Project Title: Refurbish Elevators and Replace Controls

Solicitation Questions and Answers
for
Refurbish Elevators and Replace Controls
Project: 437-22-101, RFP: 36C26324R0021
12/15/2024

Solicitation Questions and Answers (updated 3-26-2024) for
 Refurbish Elevators and Replace Controls
 Project: 437-22-101, RFP: 36C26324R0021

Project Number	437-22-101
Building Number	1,946
Drawing Number	A5.20
Dwg. 10 of 41

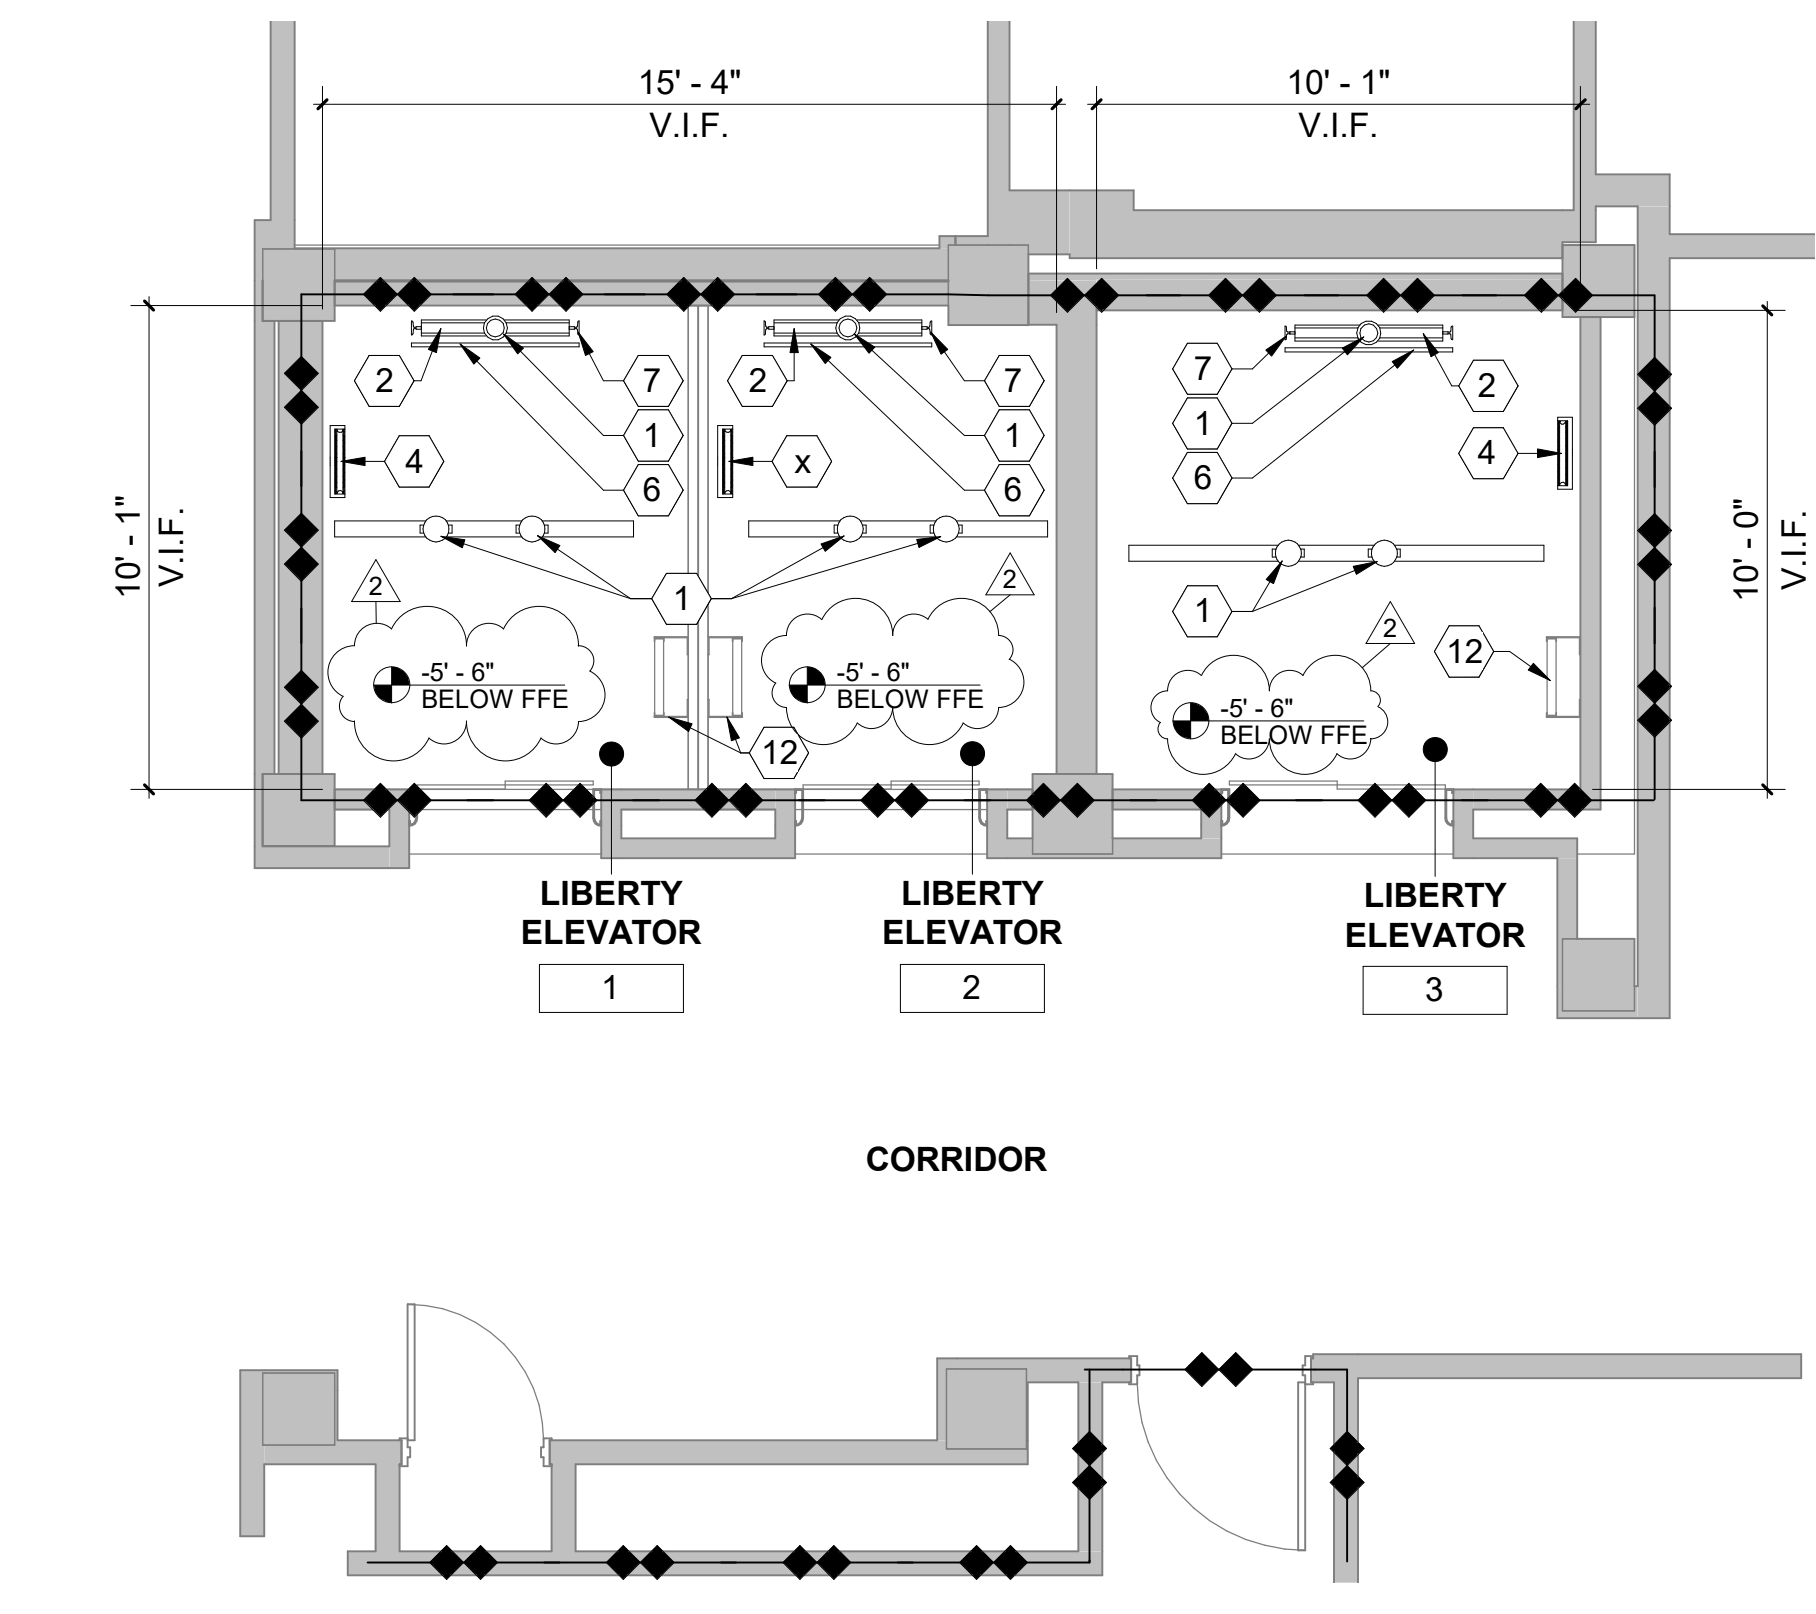
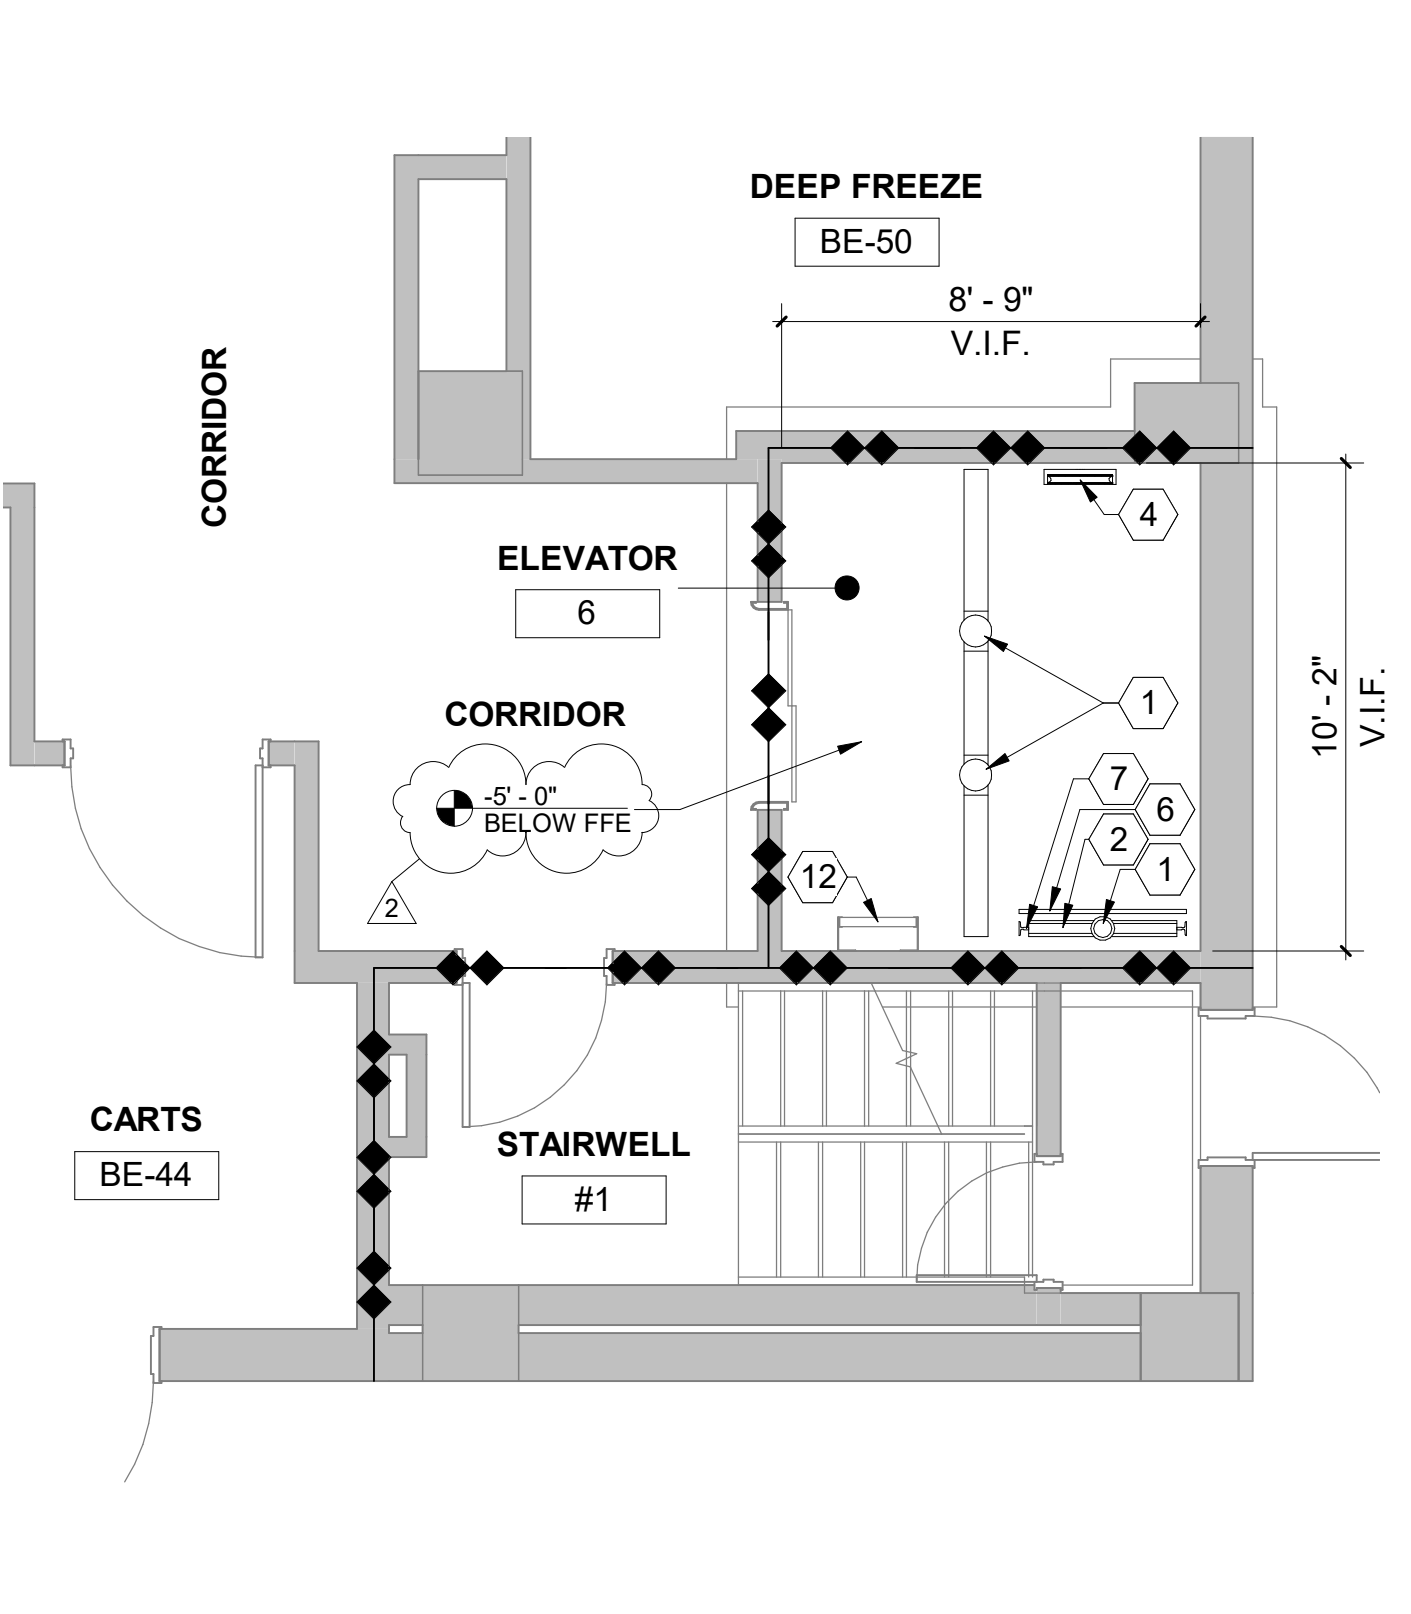
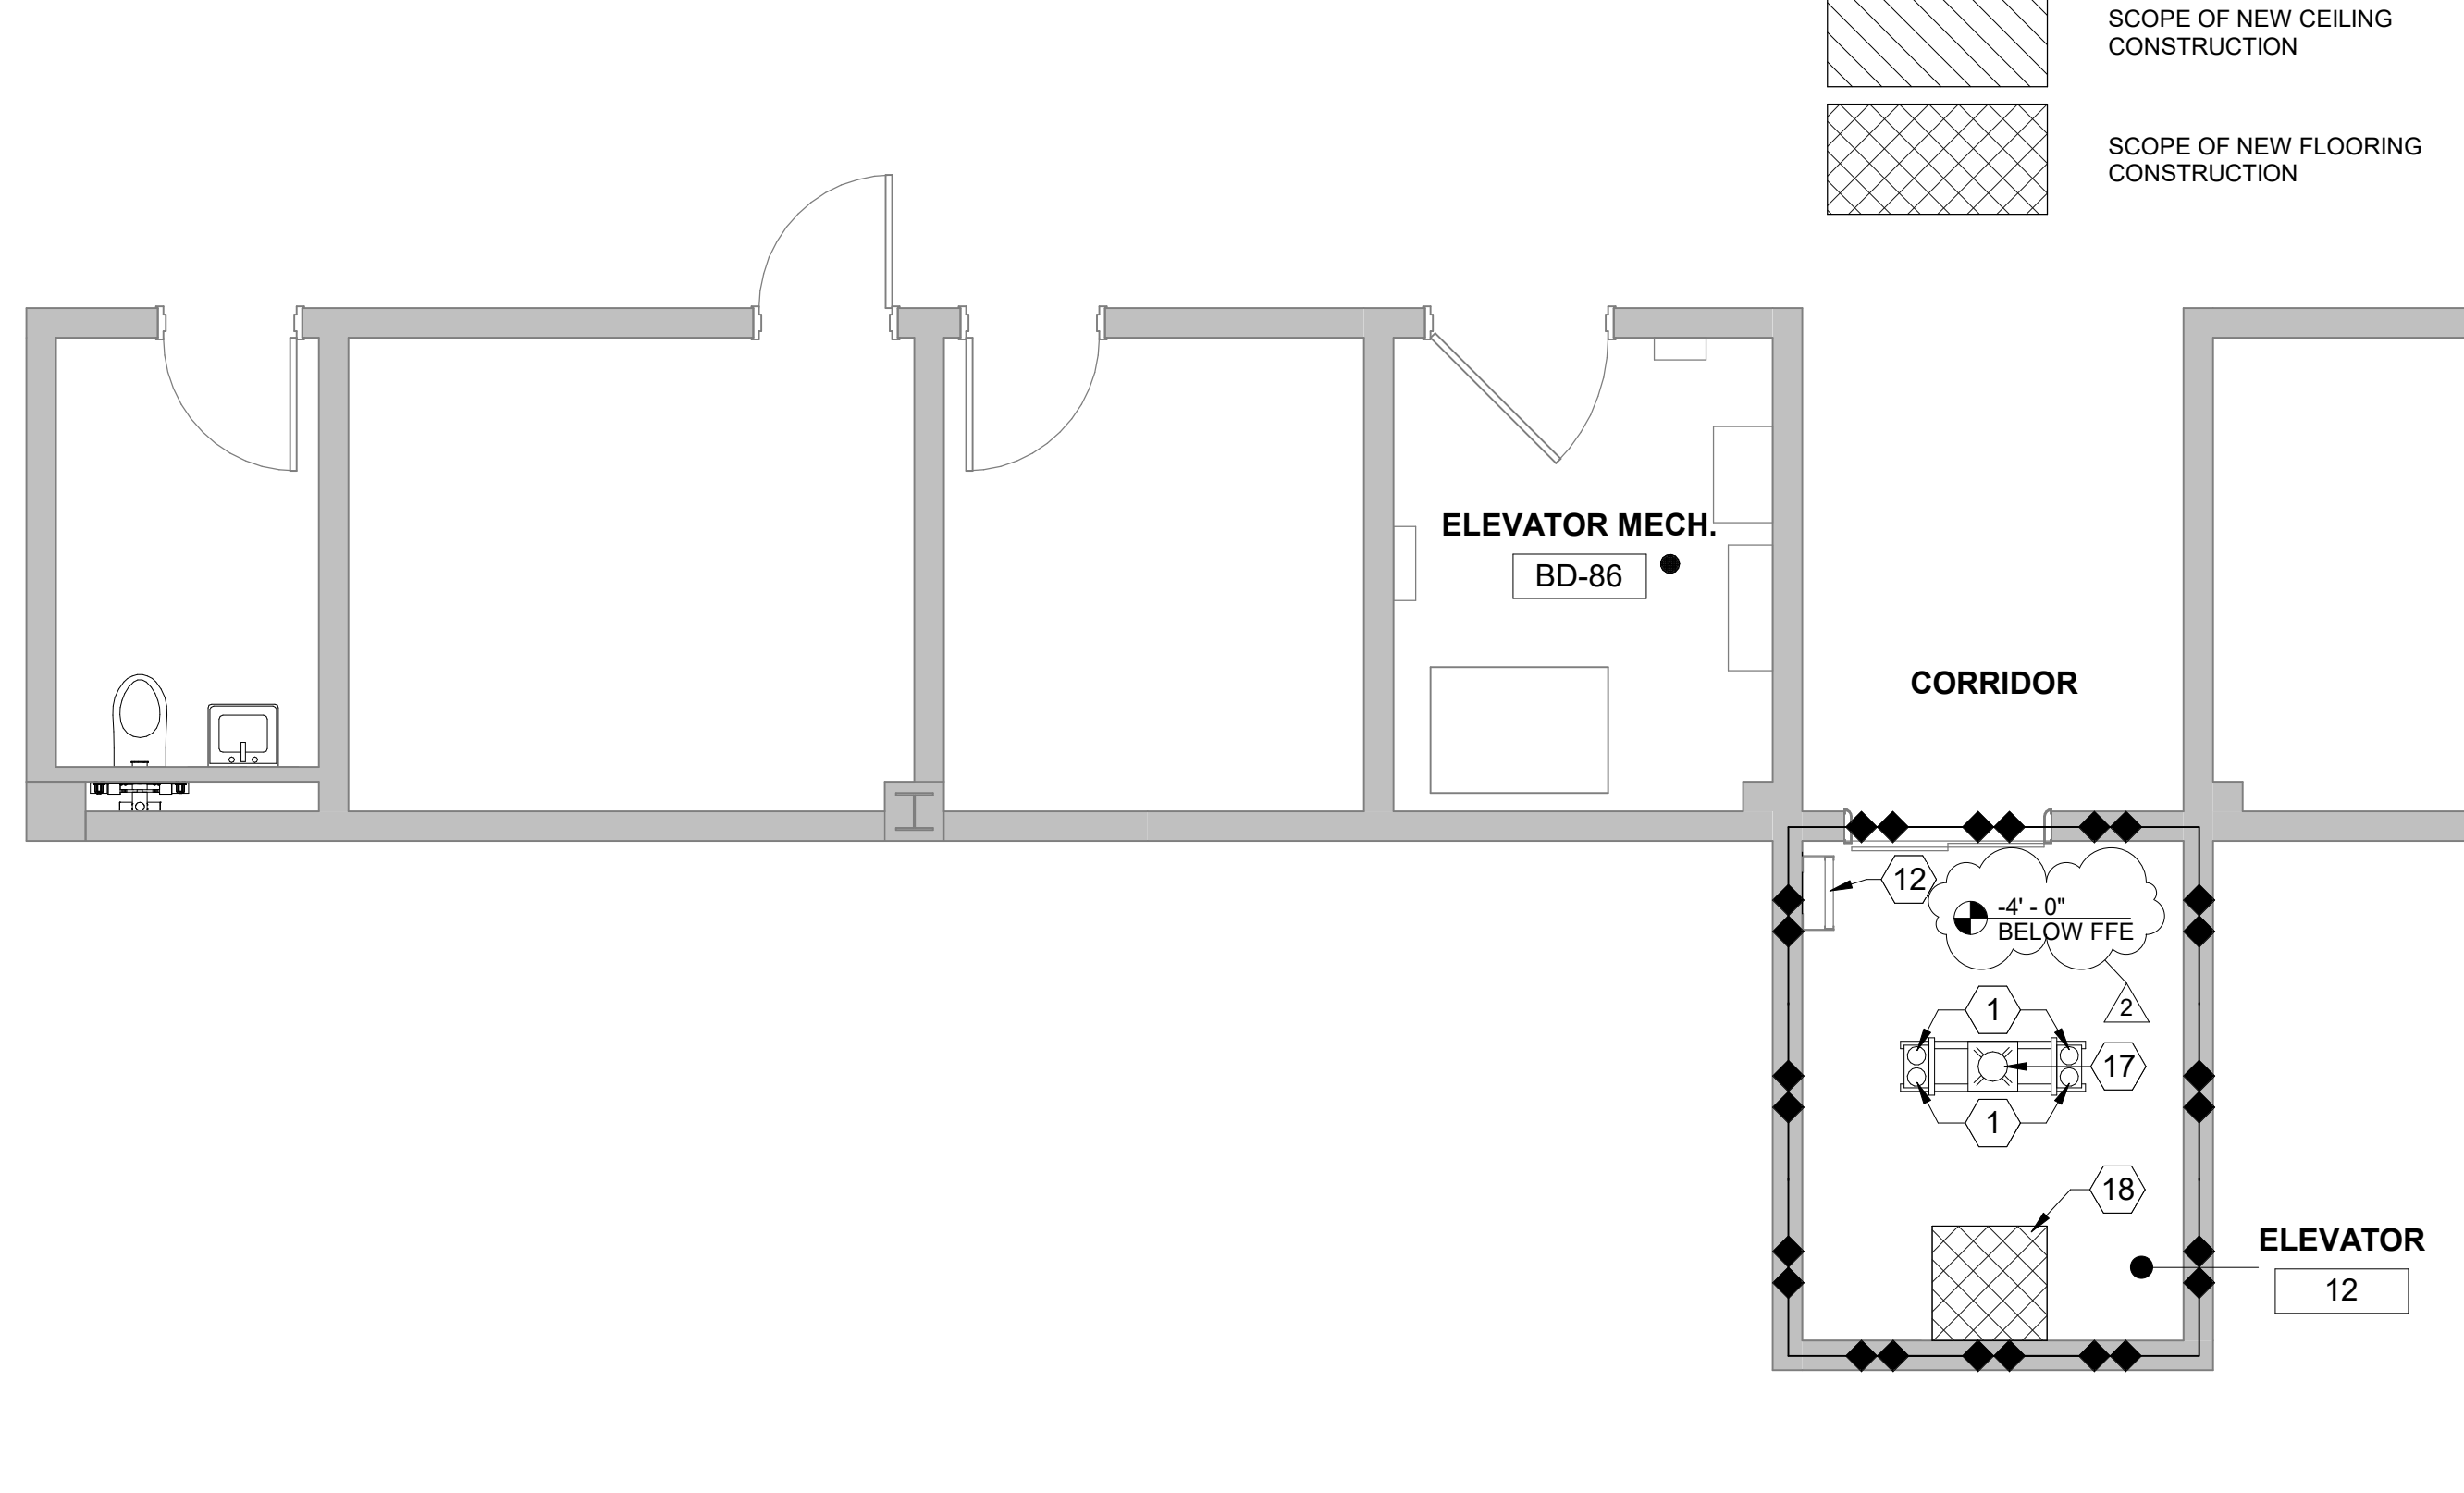
60.	2.17	2.17 - Elevator 10 does not need a casing since it is a twin post hydraulic elevator above ground. It is recommended that packing gets replaced in both jacks.	<i>Note 13/AD5.20 notes that the existing hydraulic piston is to be reused. Reuse existing hydraulic piston but replace packing in both jacks. See revised note 13/AD5.20 AND 17/A5.20.</i>

Drawing Sheet A5.20 ENLARGED PLANS – ELEVATOR PITS – See revised drawing sheet for the adjustment of keynotes # 3, 9, 15, 16, 17. Also included is the depth of each elevator pit relative to the floor elevation at the lowest elevator lobby for each hoistway.
